APPLICATION OF CELLCO PARTNERSHIP D/B/A VERIZON WIRELESS FOR A CERTIFICATE OF ENVIRONMENTAL COMPATIBILITY AND PUBLIC NEED FOR THE CONSTRUCTION, MAINTENANCE AND OPERATION OF A WIRELESS TELECOMMUNICATIONS FACILITY IN THE TOWN OF WATERFORD, CONNECTICUT

DOCKET NO. 419

RESPONSES OF CELLCO PARTNERSHIP D/B/A VERIZON WIRELESS TO CONNECTICUT SITING COUNCIL PRE-HEARING INTERROGATORIES, SET ONE

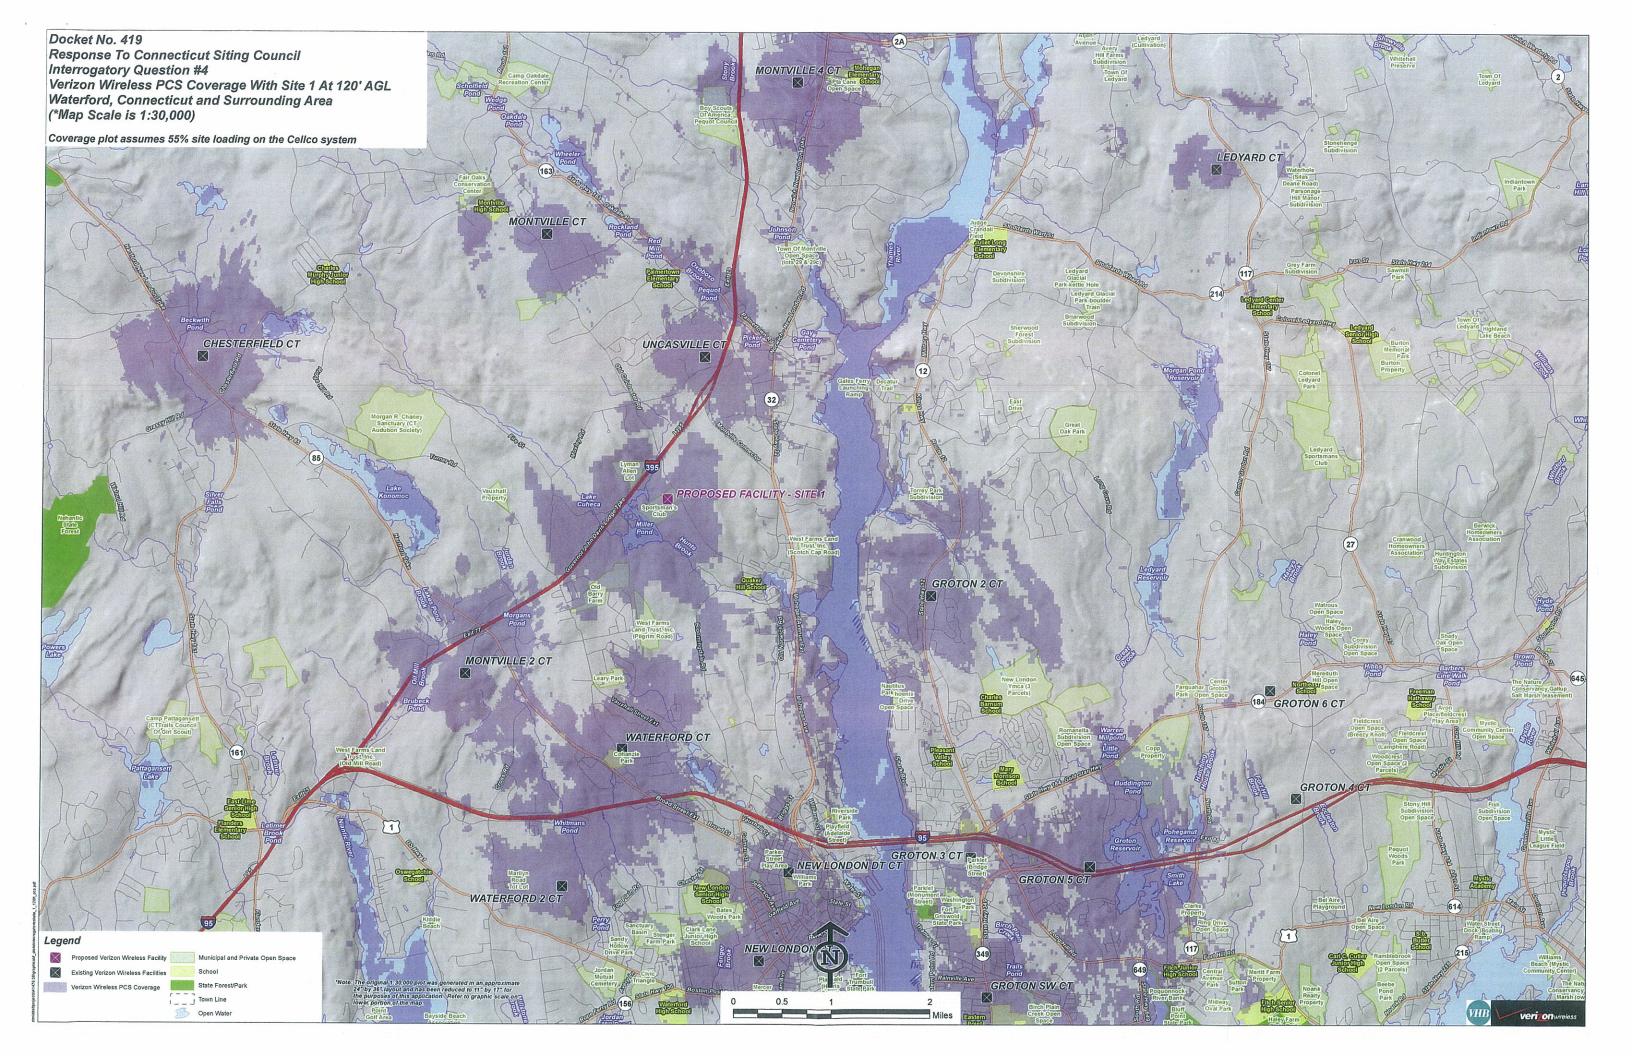
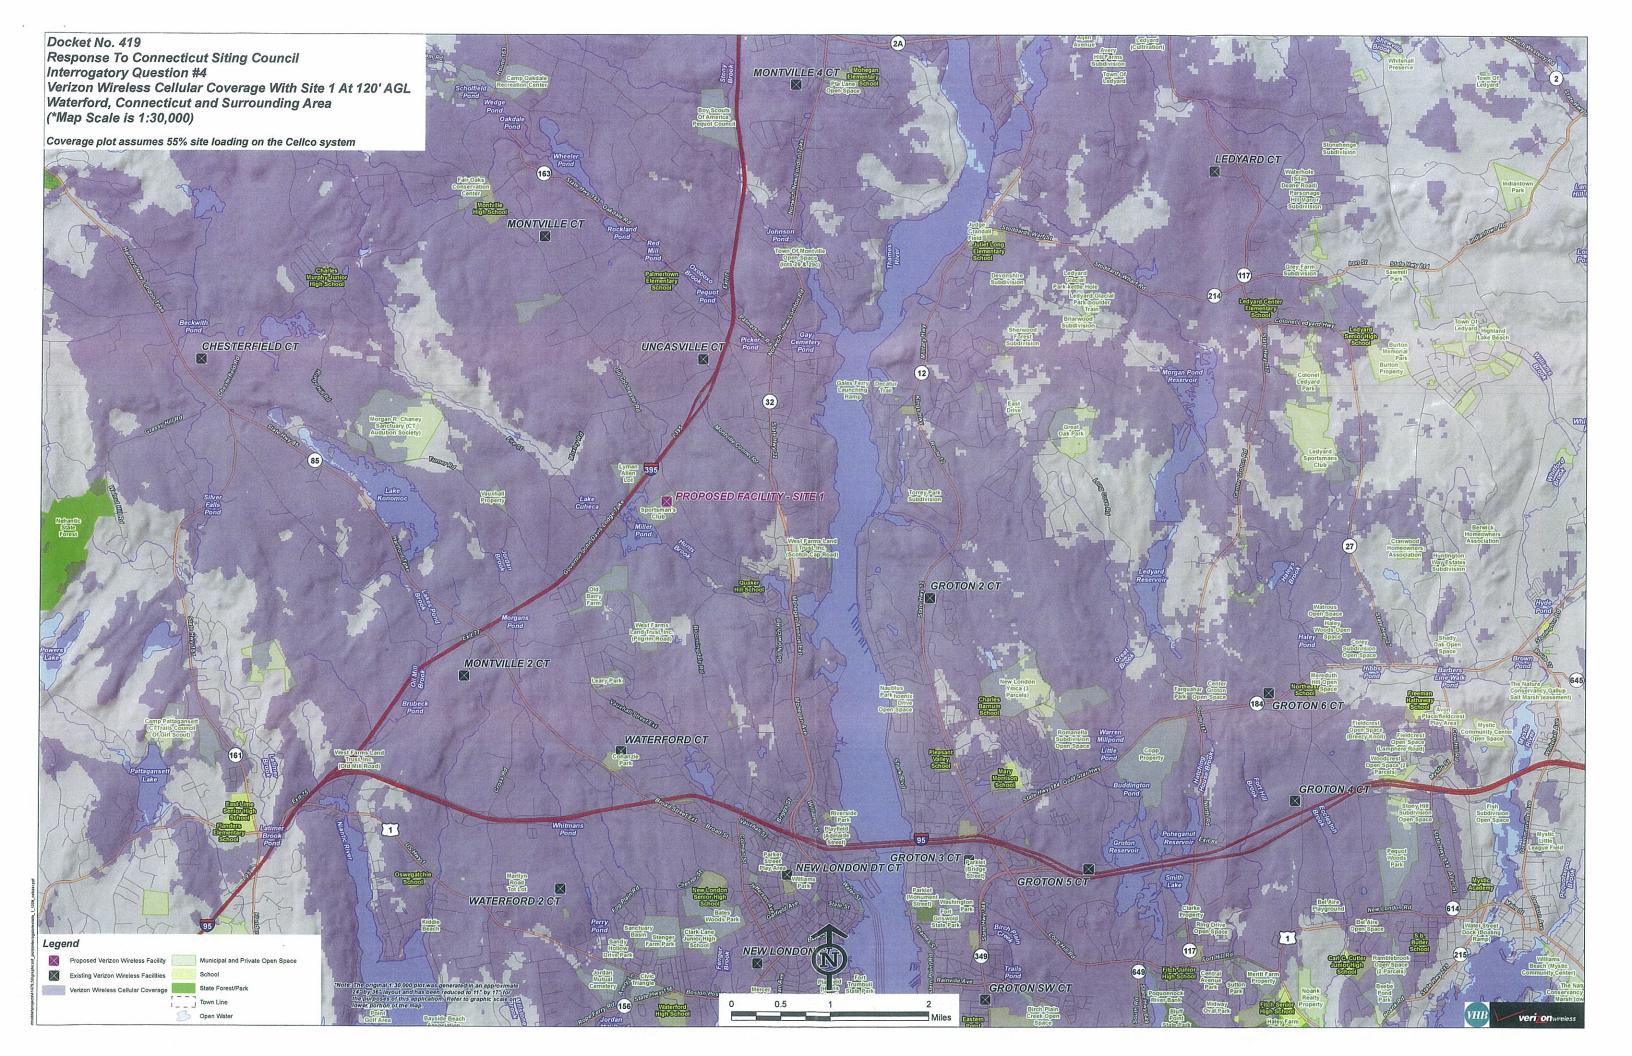
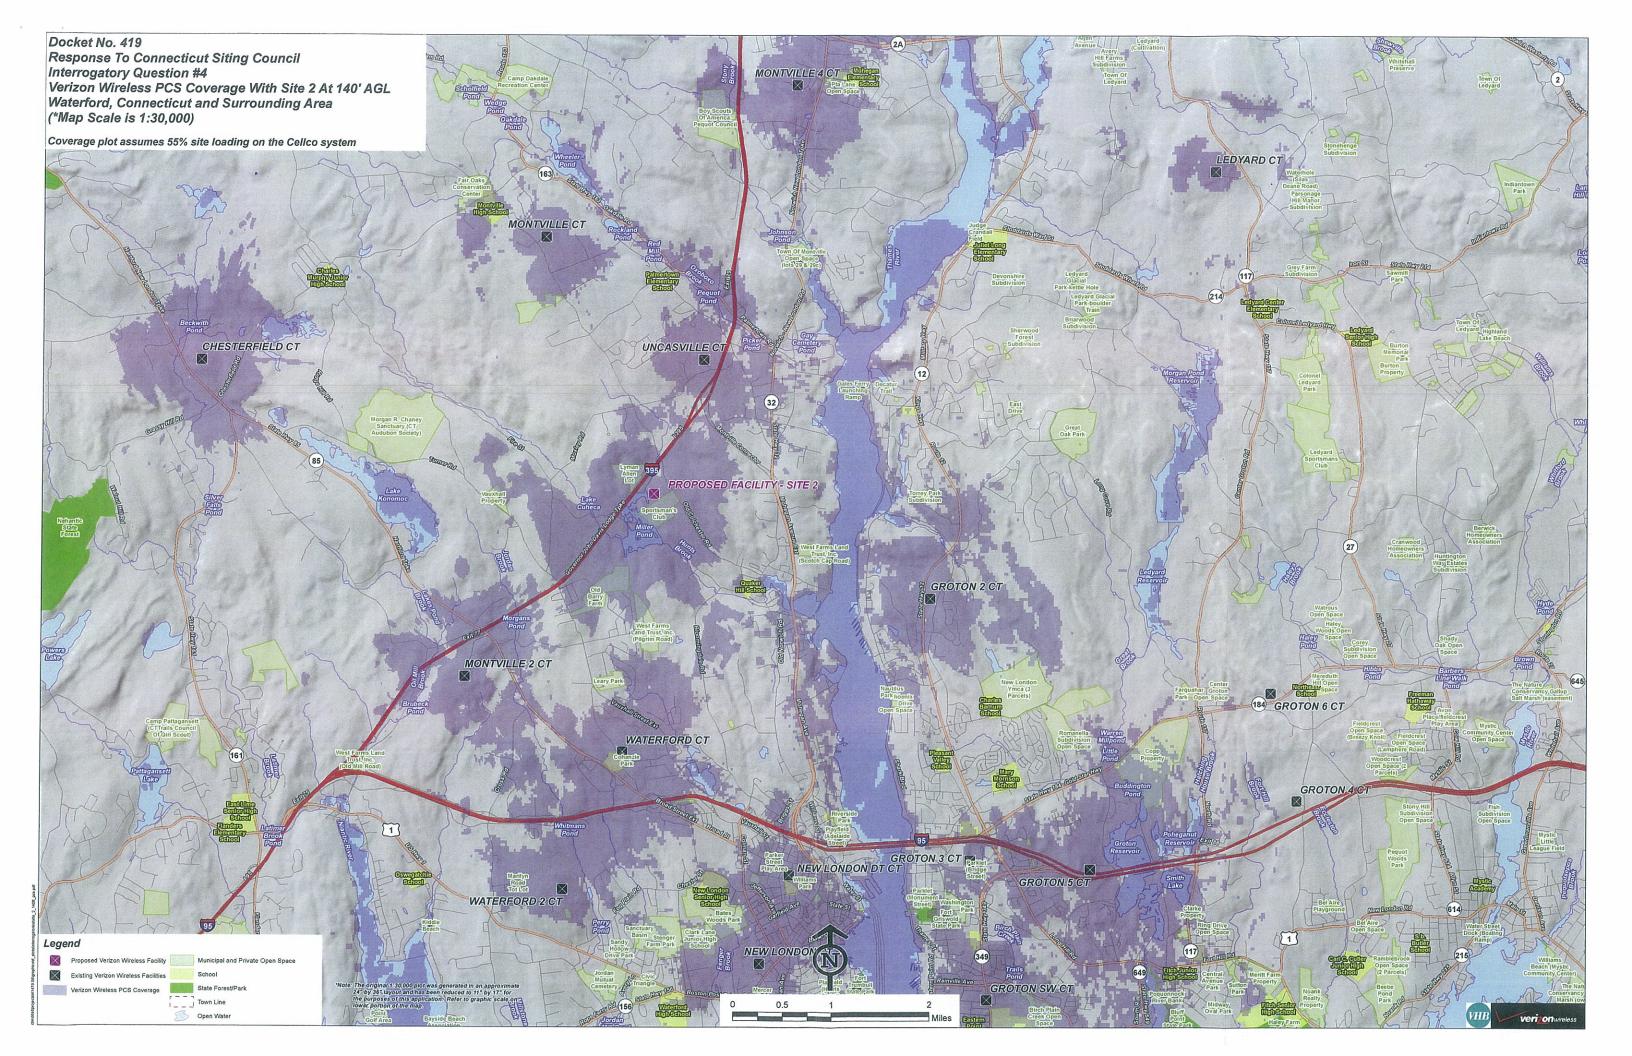
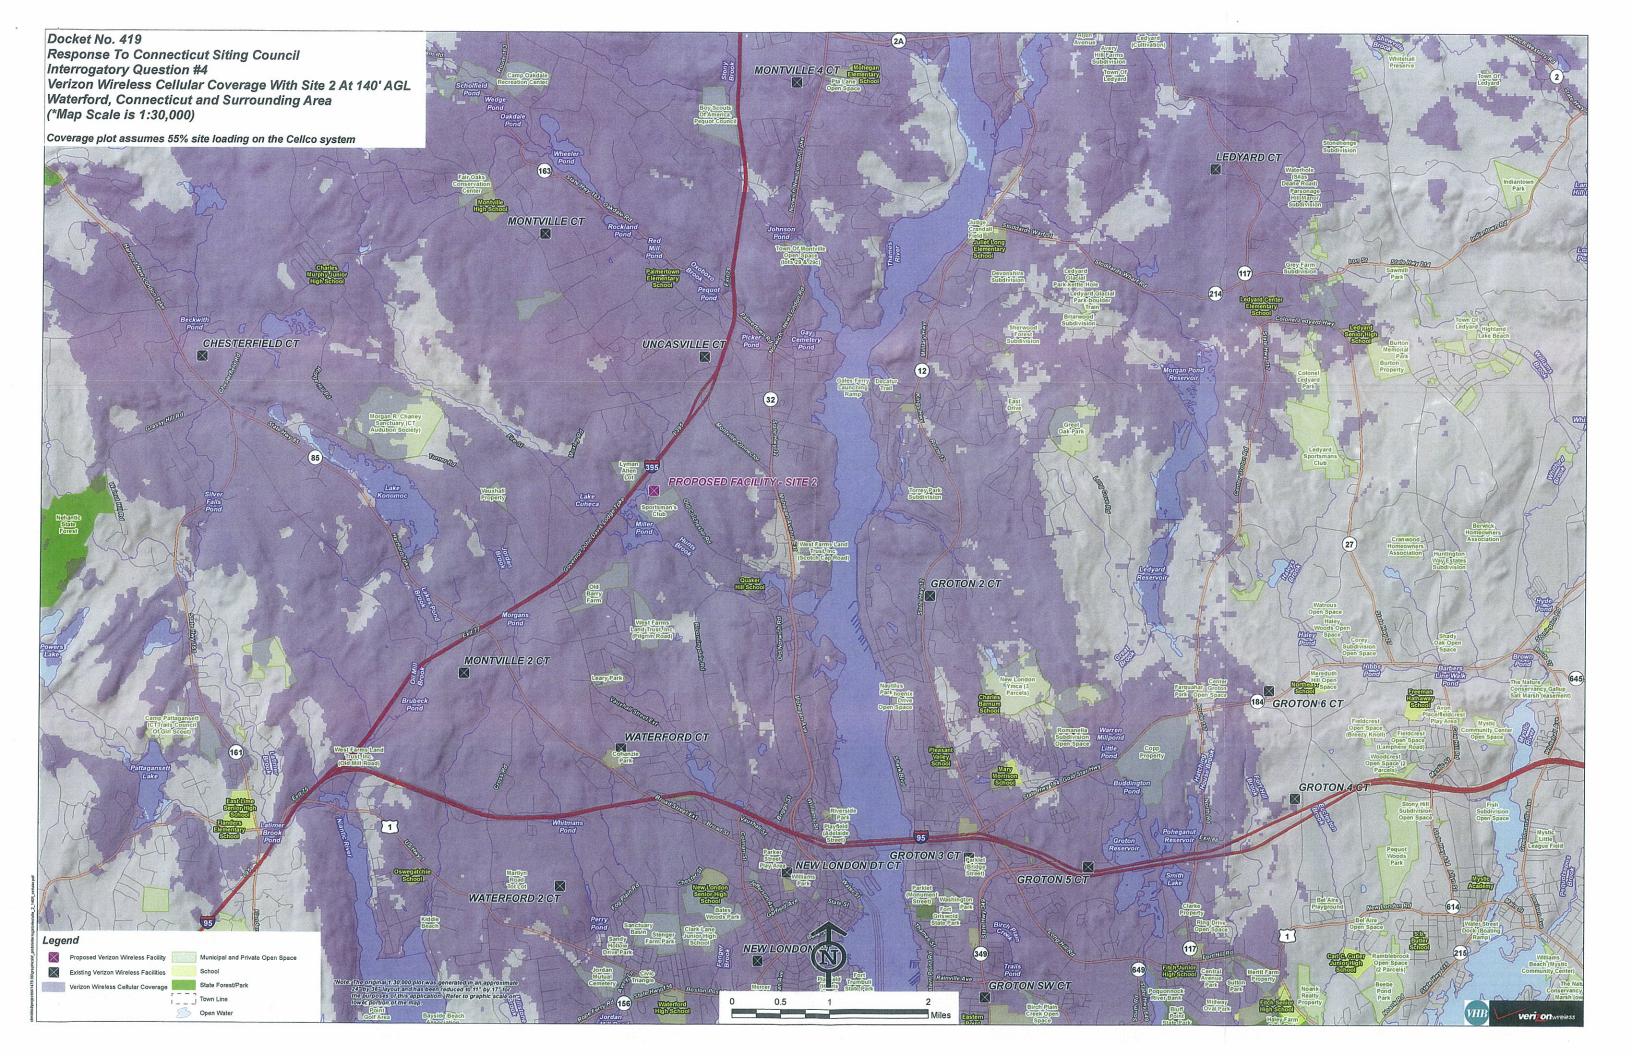
What is the lowest height at which Cellco's antennas could achieve its coverage objectives from the proposed sites? Submit propagation maps showing the coverage at ten feet below these heights.

Antennas at both Site 1 and Site 2 are proposed at the lowest height needed to allow Cellco to satisfy its Waterford NE coverage objectives. Propagation maps showing coverage from Site 1 at 120' and Site 2 at 140' (ten (10) feet lower than proposed in the application) are included in Attachment 1. As indicated on the table below, the lower antenna height results in a reduction in coverage along I-395, the primary coverage objective for the Waterford NE cell site, and a reduction in the overall coverage footprint from each of the alternative site locations.
